USB Type-C ENGINEERING CHANGE REQUEST FORM

Title: Section 4.5.2.4 Updates

Applied to: USB Type-C Specification Release 2.4, Oct 2024

Brief description of the functional changes proposed:
ECR cleans up Section 4.5.2.4 to now include addressing eMarker behavior for when the eMarker is self-powered as in some direct connect device (e.g., device with captive cable) implementations. The ECR also includes removal of an unnecessary requirement that explicitly disallowed SOP' responses during the Cable Power On State since a Source can't readily determine that the eMarker is actually in this state and nor does it matter.

Figure 4-20 ~~Passive~~ Cable eMarker State Diagram

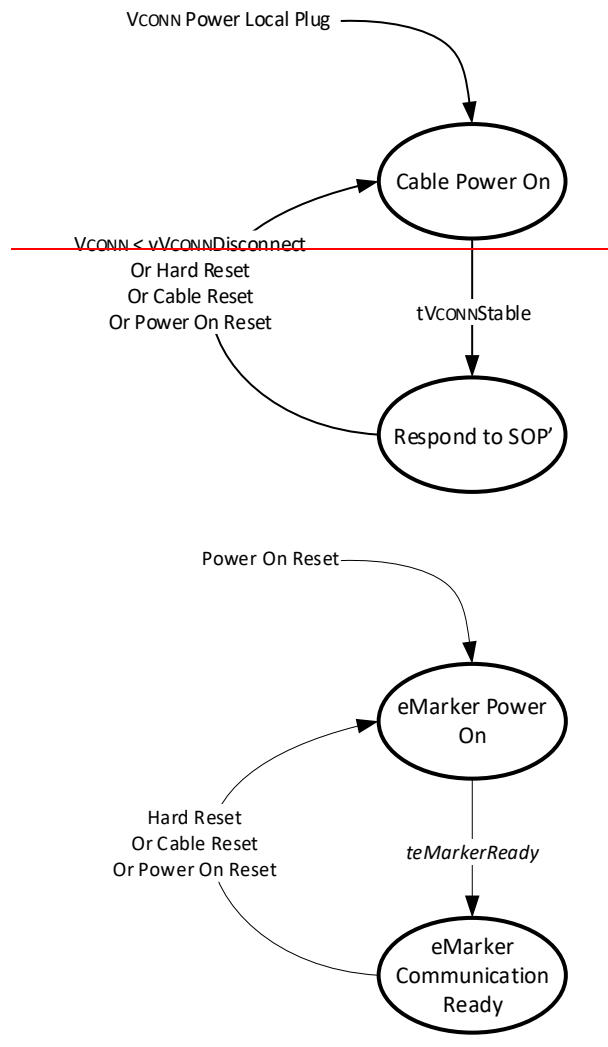
Figure 4-20 and Figure 4-21 illustrates the cable eMarker connection state diagrams for passive and active cables, respectively. The requirements in this section also apply to an eMarker that is in a direct connect device.

This state appears in Figure 4-20. This is the initial power on state for each eMarker ~~in the cable~~ when VCONN or VBUS is applied.

Each eMarker ~~in the cable~~ **shall** initialize when power on is applied.

~~The cable **shall not** respond to SOP' and SOP'' commands in this state.~~

Each eMarker ~~in a passive or active cable~~ **shall** transition to Assign Cable SOP* the eMarker Communication Ready State when it has completed its boot process. Each eMarker **shall** transition to Assign Cable SOP* the eMarker Communication Ready State within ~~tVCONN Stable~~ teMarkerReady.

This state appears in Figure 4-20 ~~and Figure 4-21.~~

~~A passive cable has only one eMarker powered at a time. This cable eMarker in a passive cable **shall** respond to SOP' in this state.~~

~~Each cable eMarker in an active cable **shall** respond to a pre-set SOP' or SOP''. If only one eMarker exists in the cable, it **shall** only respond to SOP'.~~
